Southern Oregon University
Hannon Library - Membrane Roof Replacement
ITB 2025-22
March 28, 2025

Addendum #1

1 EXTERIOR WALL @ PARAPET
 AB.07 SCALE: 1-1/2" = 1'-0"

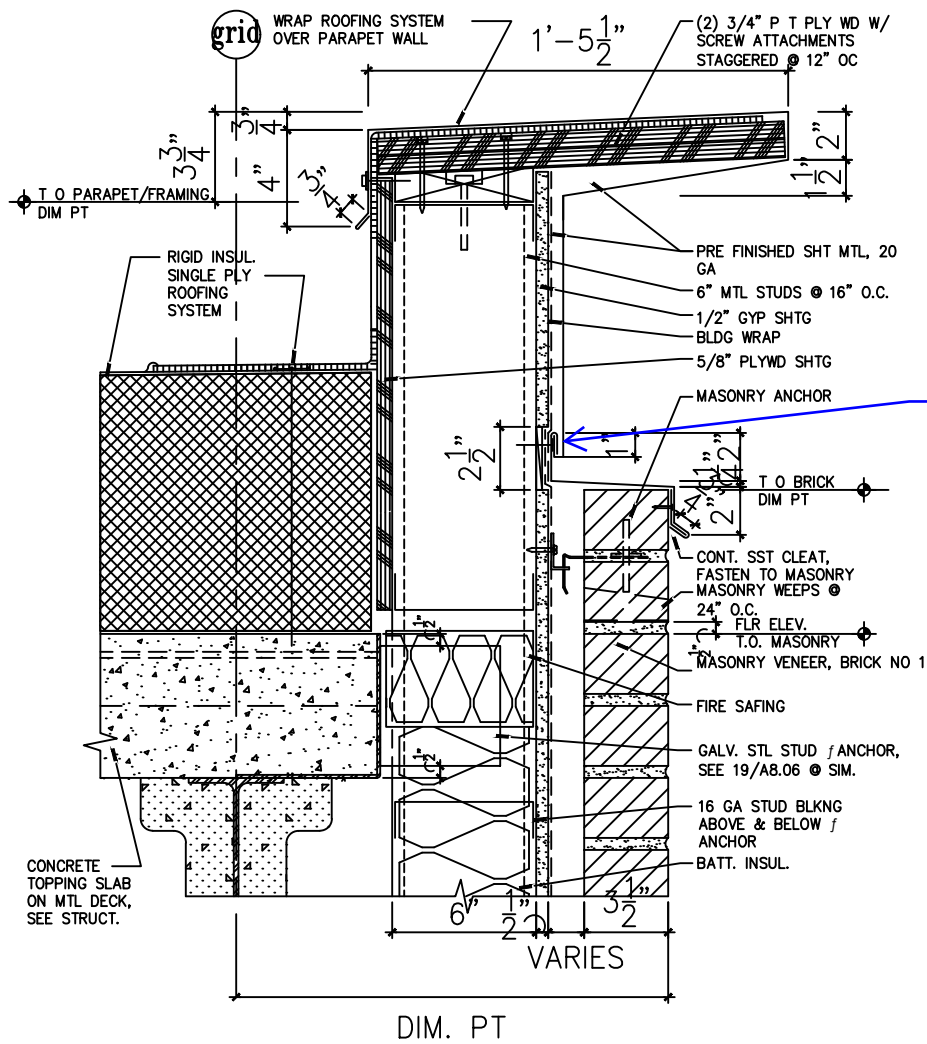
See attached drawing 1/A807 showing parapet construction details. Detail drawing is from the 2003 building addition and renovation - construction drawings.

Typical Parapet Coping – New Roof

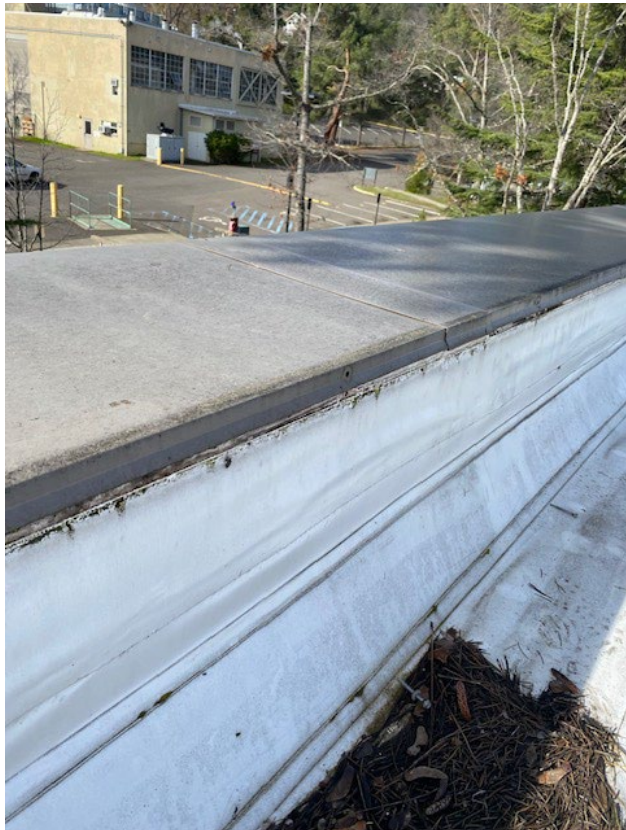
Parapet coping joints (10'-0" on center, typical) have metal backing strips and pre-finished cover strips with stainless steel rivets and caulking at each joint. There is a double layer of 3/4" PT plywood under the metal cap. The existing single ply membrane extends over the outside edge of the parapet cap. It should be possible to remove and replace long sections of cap metal without opening up each riveted joint.
